Subject: RATTLE NOISE FROM FRONT DOOR GLASS	Bulletin No: 09-016/15
	Last Issued: 05/18/2015

- This bulletin supersedes the previous bulletins 09-017/14 issued 08/29/14, 03/05/14 and 08/18/14 and 09-011/13 issued 04/17/13. The APPLICABLE MODEL(S)/VINS, DESCRIPTION, REPAIR PROCEDURE, PART(S) and WARRANTY INFORMATION have been revised.
- Changes are noted below in Red beside the change bar.

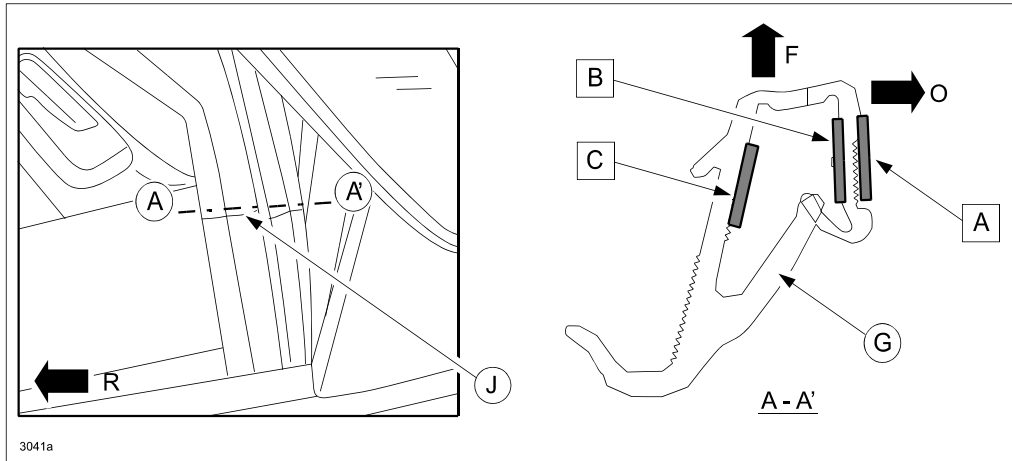
1. Verify the customer concern. The rattle noise should go away when holding the slightly opened window by hand or when the window is completely closed.
 - If the noise goes away, proceed to the next step to attach non-woven pads to Positions (A), (B) and (C) of the glass run channel (G) as shown.

NOTE: Depending on vehicle types (production change levels), non-woven pads or resin foam have already been attached to Position C or Positions A and C. In this case, it is not necessary to attach additional non-woven pads to these position(s).

b. Position B

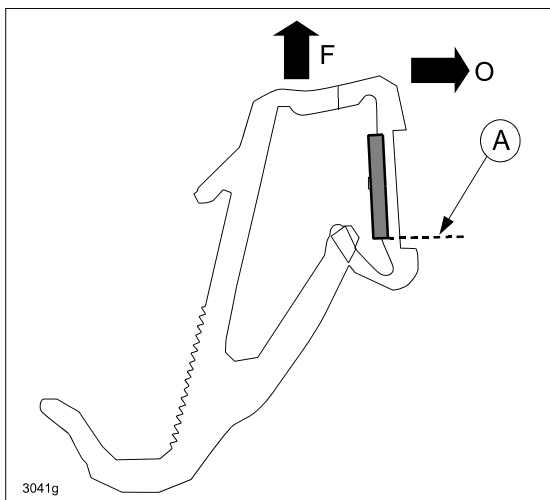
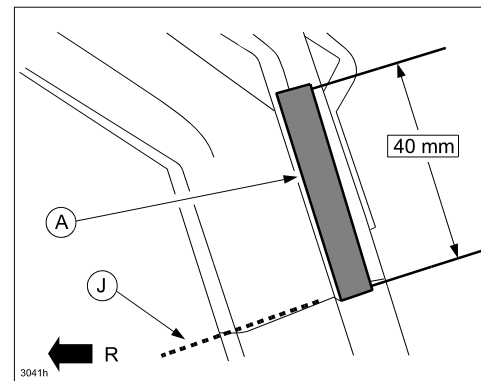
Attach the pad along the uneven line of the back side of the lip (A).
 F=Front; O=Outer

For All Vehicle Types
 Attach pad of 40mm length (A) right above the molded joint line (J).

c. Position C

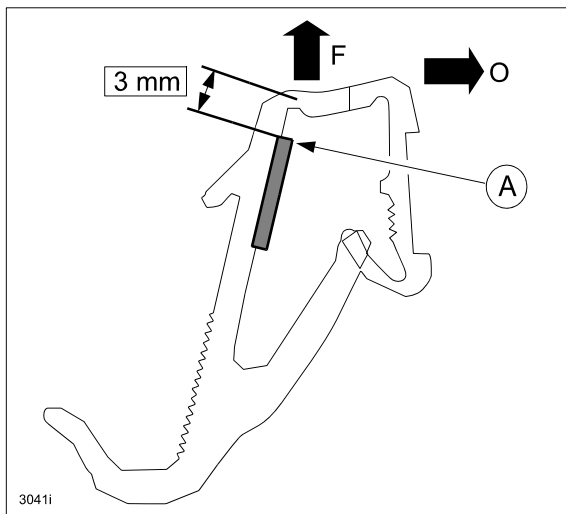
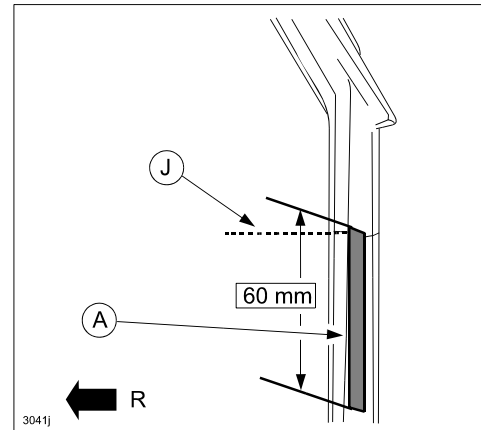
Attach pad positioning it 3mm away (A) from the back of lip.
 F=Front; O=Outer

Attach pad (A) of 60mm length right below jointed line (J).
